**LEGAL ADVERTISEMENT
HISTORIC PRESERVATION BOARD
CITY OF PORTLAND
Public comments are taken at all meetings.**

**HISTORIC PRESERVATION BOARD
CITY OF PORTLAND, MAINE**

**PUBLIC HEARING
276 BRACKETT STREET**

RE: June 7, 2017 Public Hearing – Final Review of Proposed
Garage Addition

PROPOSED SECTION OPTION B

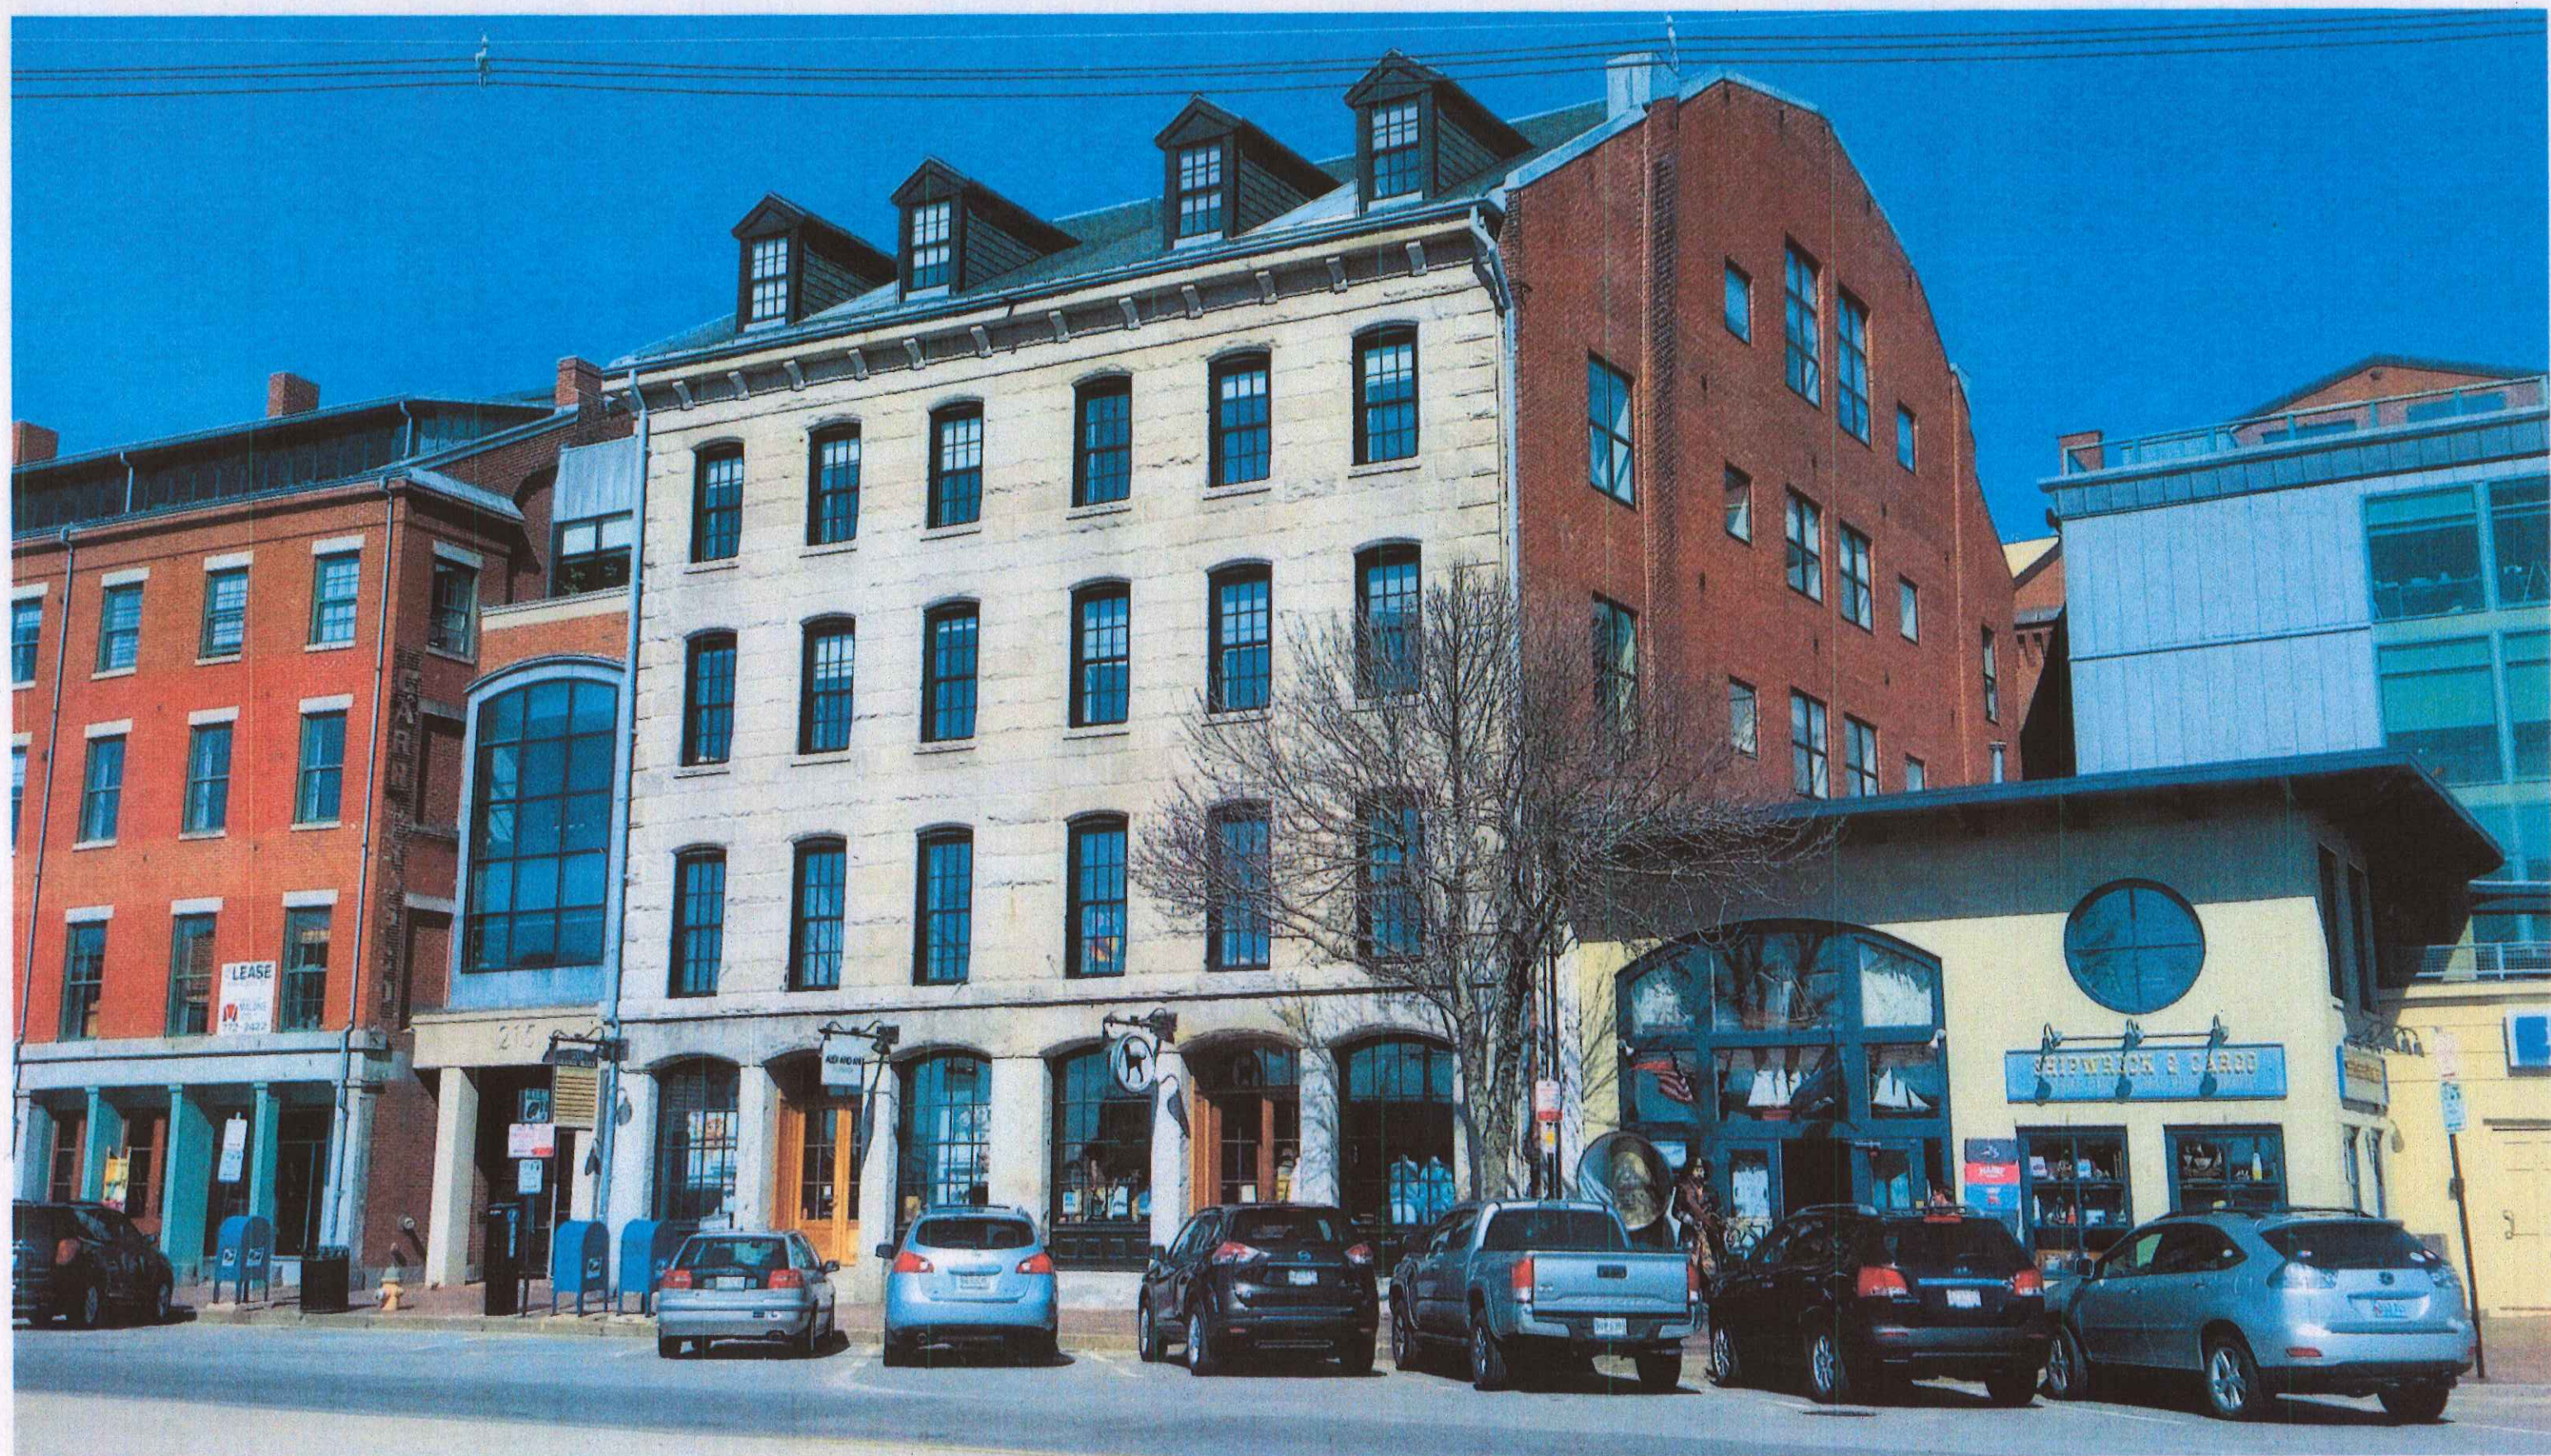
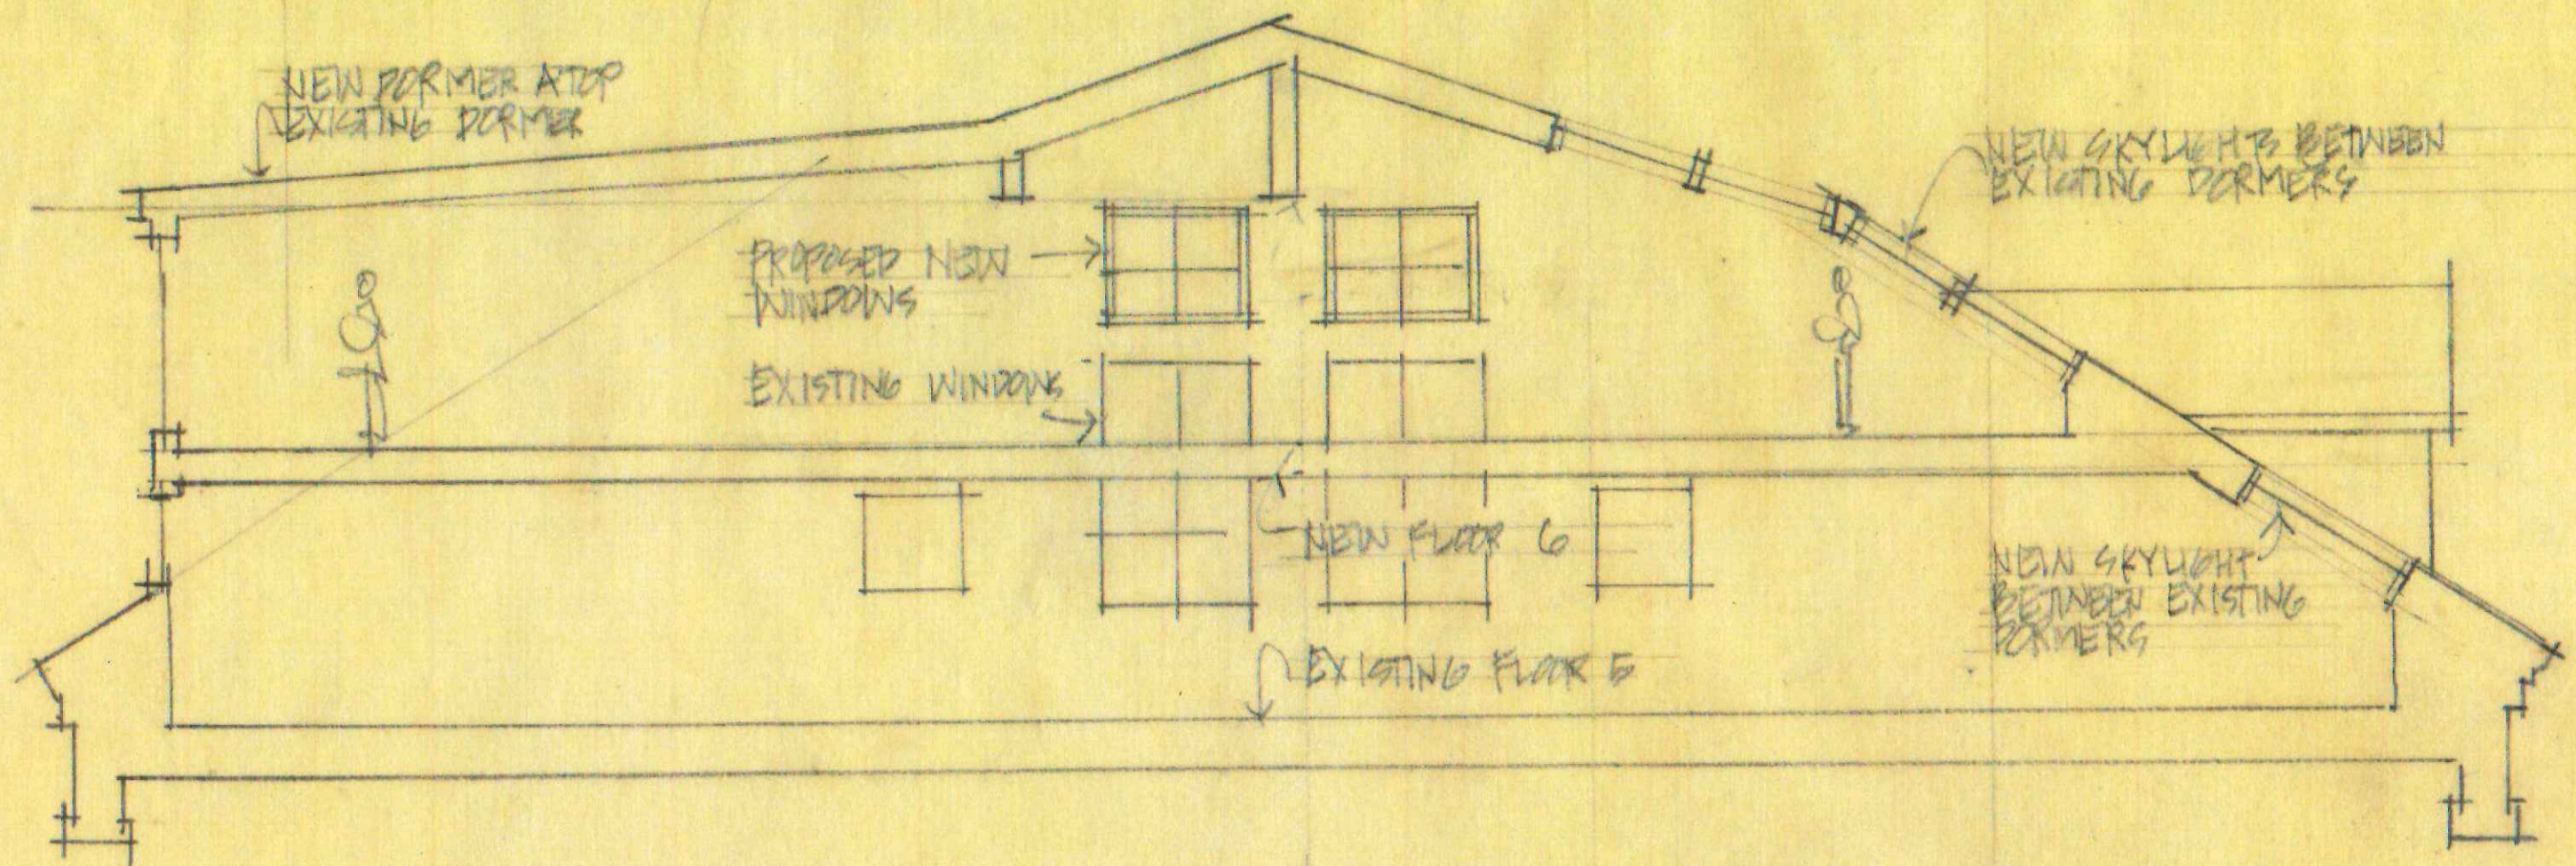
Option B proposes new reversed, cut-out dormers between each pair of existing dormers. The exact geometry, including location of the dormer wall and the height of the sills and headers have yet to be clearly defined.

Option B shows reverse cut-out dormer windows with an extended deep sill (7' +/-), the exact depth will be determined by the geometry of the window head height where it intersects the roof plane.
